SB-10046979-5195SI M17 07 12
Cooling SystemsSeptember 2012
Technical Service

SUBJECT**Service Action: Retrofit of the Engine Coolant Temperature Sensor****MODEL**

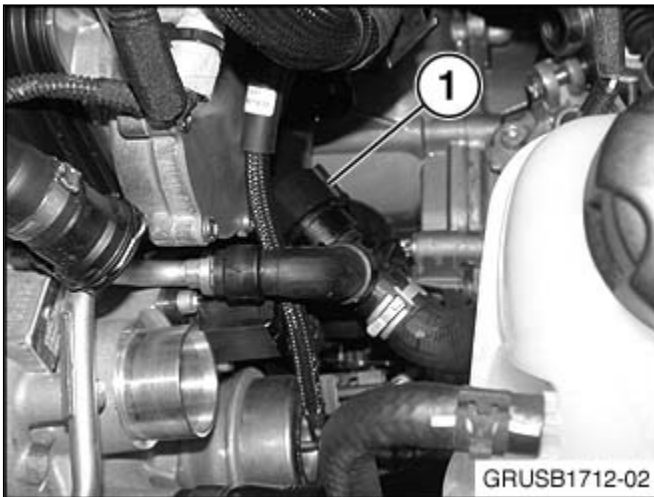
Remove the coolant hose (1). This hose will not be reused.

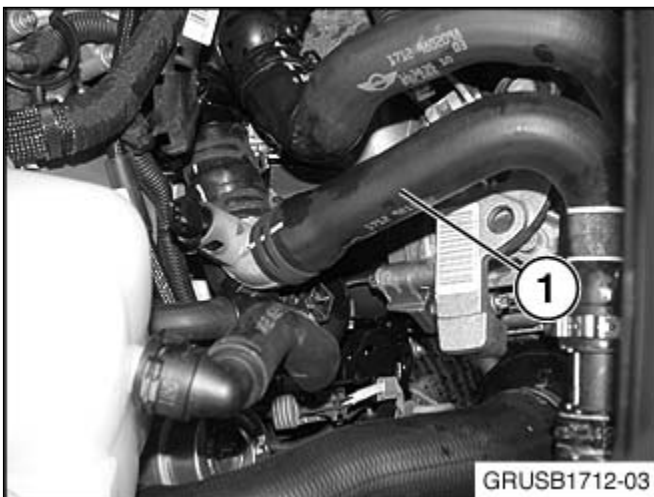
N18 engine only! Install spacer P/N 64 53 7 578 707 (1) on the coolant line as shown.

Note: The spacer needs to stay in this position when installing the new coolant hose P/N 17 12 7 647 004 (next step).

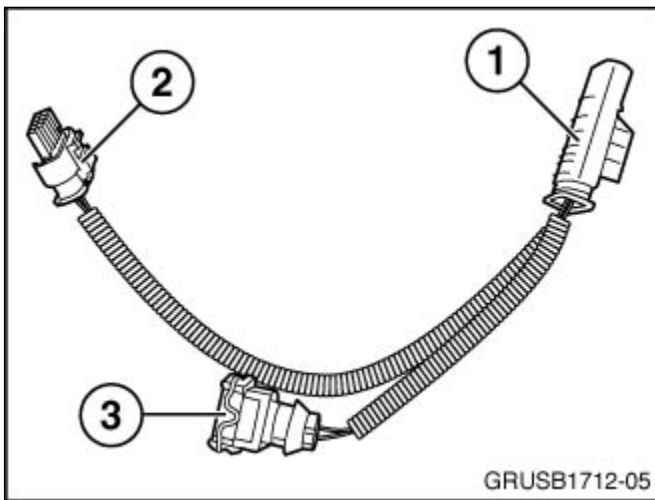
Install the new coolant hose with sensor P/N 17 12 7 647 004 (1).

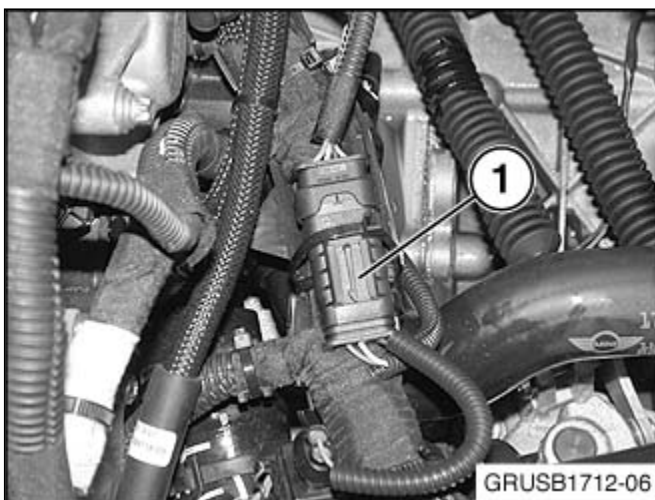
Unplug connector X6279 from the engine thermostat (1).

Plug connector X6279 into the 4-pin male connector (1) of adapter harness P/N 12 51 7 647 200. Insert the 4-pin female connector (2) of the adapter harness into the engine thermostat. Plug the 2-pin female connector (3) from the adapter harness into the engine temperature sensor of hose P/N 17 12 7 647 004.
